**DEVELOPMENT APPLICATION: WALSH BAY ARTS PRECINCT STAGE 2 AND SYDNEY THEATRE COMPANY INTERNAL FIT-OUT AND REFURBISHMENT WORKS
FILE NO: R/2016/21/A AND R/2016/13/A**

DEVELOPMENT APPLICATION NO: SSD 7689 AND SSD 7561

The CSPC endorse the key issues as detailed in the subject report as representative of the views of the CSPC on the Walsh Bay Arts Precinct SSD applications 7689 and 7561.

Figure 10: Preserve sight lines

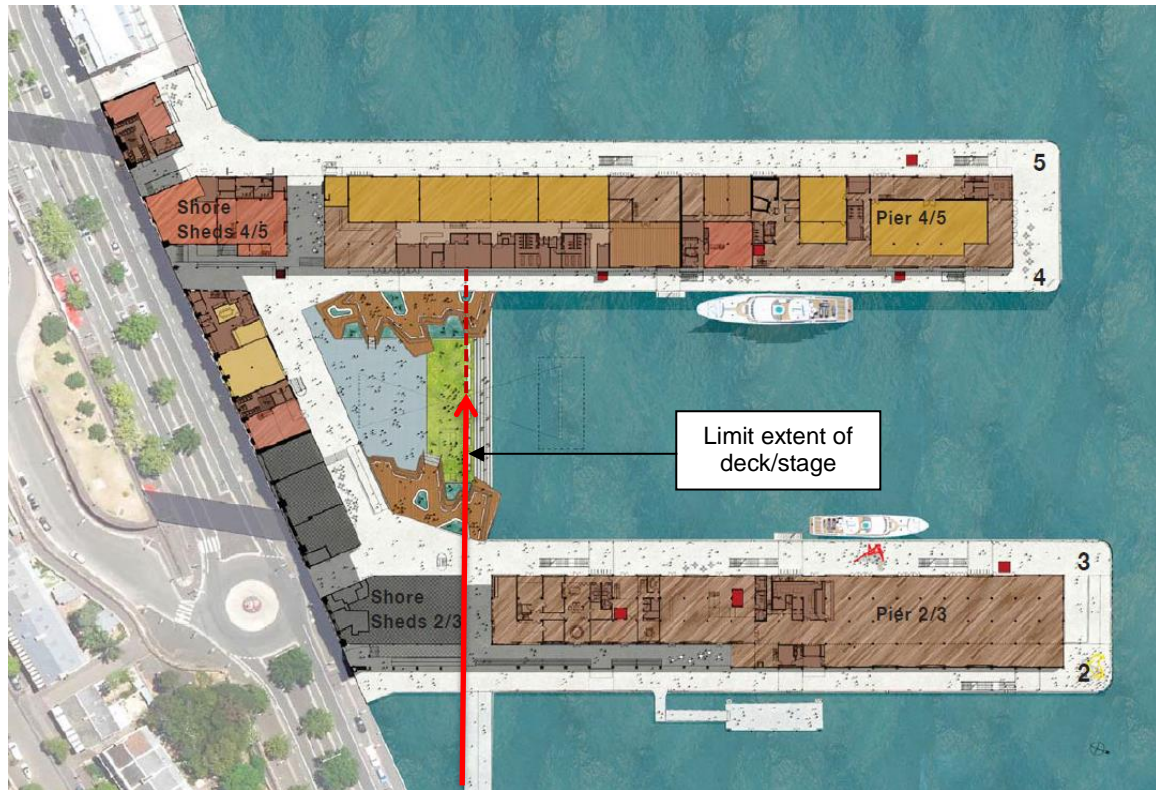
- a. any development of a detailed Stage 2 proposal should not extend in the northerly direction (waterside) beyond the southern side of the Pier 2/3 shore shed 'breezeway' and axis of bridge from Pier 1. When a pedestrian is walking on the bridge from Pier 1 to Pier 2/3, their view of the water should not be interrupted by the deck/stage infill. All structures should be contained within a line extending from the face of the Pier 2/3 shore shed (Figure 10);
